**Attachment No. 7
Item No.: 19B-SIG-01**

NCUTCD Approved Changes to the Manual on Uniform Traffic Control Devices

TECHNICAL COMMITTEE:	Signals Technical Committee
ITEM NUMBER:	19B-SIG-01
TOPIC:	Use of Straight-Through GREEN ARROW
ORIGIN OF REQUEST:	Signals Technical Committee
AFFECTED SECTIONS OF MUTCD:	Section 4D.05 <u>4F.01</u> Application of Steady <u>and Flashing</u> Signal Indications <u>during Steady (Stop-and-Go) Operation</u>

Proposal is to allow for the use of a straight-through GREEN ARROW opposed by an approach with a CIRCULAR GREEN or a flashing YELLOW ARROW.

20 Diamond Interchange

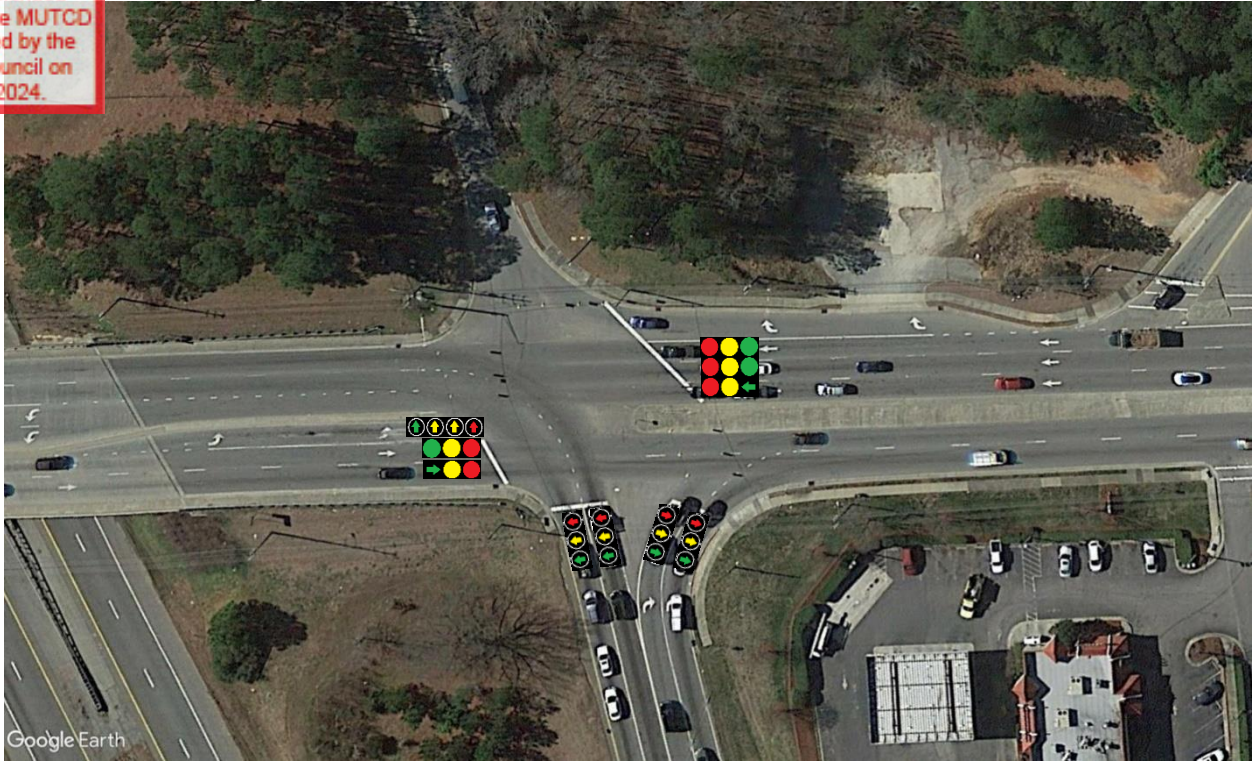
The use of a straight-through GREEN ARROW is currently allowed in the MUTCD in locations where there are no movements in conflict. However, in practice, this indication can be used to also indicate to a driver that no turn is allowed in this lane. This indication would be useful in locations where through vehicles cannot make a turn but are opposed by left turn vehicles facing a CIRCULAR GREEN or flashing YELLOW ARROW. This scenario can be seen at diamond interchanges and alternative intersection designs. Examples of the applications are shown below:

05 ~~If not otherwise prohibited, to discourage wrong way turns, a~~ A steady straight-through GREEN ARROW signal indication may be used instead of a CIRCULAR GREEN signal indication in a signal face, to discourage wrong way turns under the following conditions, even if opposed by a simultaneous permissive left-turn movement:

A. on an approach intersecting a one-way street; ~~to discourage wrong way turns.~~

B. on an approach intersecting an interchange exit ramp; or

C. on an approach with unique geometric design that prohibits turns.
